Regulatory Submission for period 2021/22 to 2025/26

# **JEMENA - REVIEW OF PROPOSED FUTURE GRID AND CYBER SECURITY OPEX STEP CHANGES**

Report prepared for:  
**AUSTRALIAN ENERGY  
REGULATOR**  
August 2020

Figure 2.1: Jemena’s forecast PV generating customers and constraints (central case scenario)

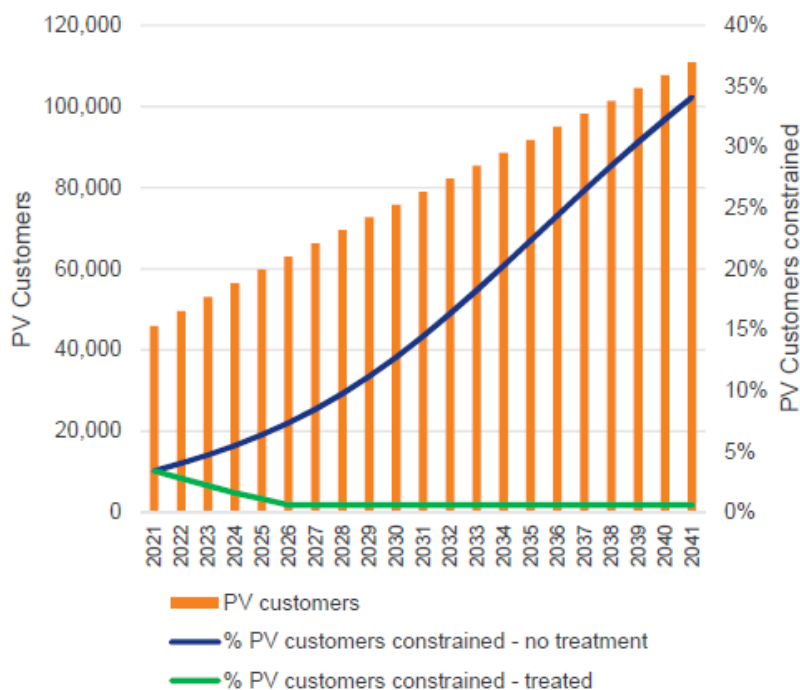
11. Jemena’s solar PV penetration is currently 10% and it forecasts that this will grow to 28% by 2025/26.<sup>6</sup>
12. Increased distributed generation such as from rooftop solar has the effect of raising the voltage at the LV level. Customer solar system inverters which are compliant with AS4777 are set to trip when voltage exceeds set thresholds to avoid over-voltage supply in the LV system to which its connected. Jemena’s forecast of constraints over time is shown in Figure 2.1 below.

- Jemena’s proposed solar enablement program is intended to reduce the extent to which over-voltage occurs and therefore the extent to which exported solar from customers’ systems is constrained.

Figure 2.3: Jemena’s proposed approach to DER enablement – ‘building smart’

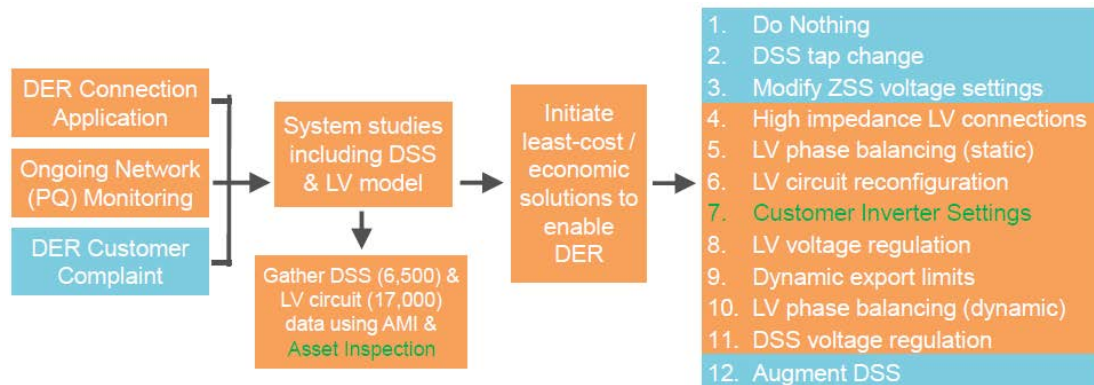
- building smart – its recommended approach, illustrated in Figure 2.3 below, which also highlights (in green) two of the three opex requirements.
